Service Bulletin

No. : MZ07-069

Model: SR7300, SR7300F

Subject: Software Update Information.

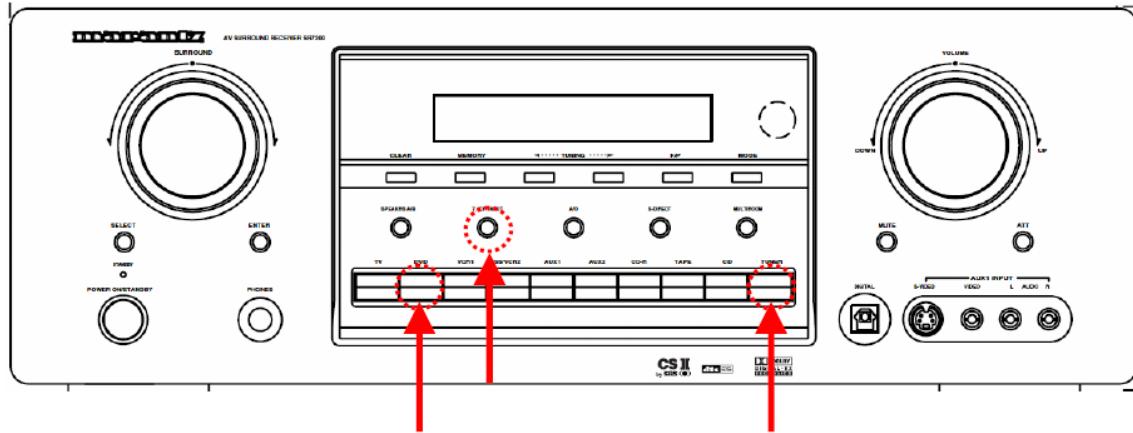
BEFORE UPDATE

Originally, the unit was designed to go into STANDBY mode upon detection of an abnormality with the STANDBY LED flickering every 500m sec. it would never be powered on by the standby switch or the remote control, so component over dissipation never occurred. However, if the unit was plugged in again, it could occur before the unit went into standby a few seconds later.

AFTER UPDATE

The unit has been modified never to be powered on by any means once it goes into standby with the standby led flickering every 125m sec., unless the specialized procedure (*1) described below is performed.

***1: If the unit cannot be powered on after being plugged in again (with the STANDBY LED flickering every 125m seconds), the power amp has been damaged. The unit still can be powered on again through the following method,**

Set can be powered on by “FACTORY” KEY = [DVD] + [TUNER] + [7.1CH INPUT].
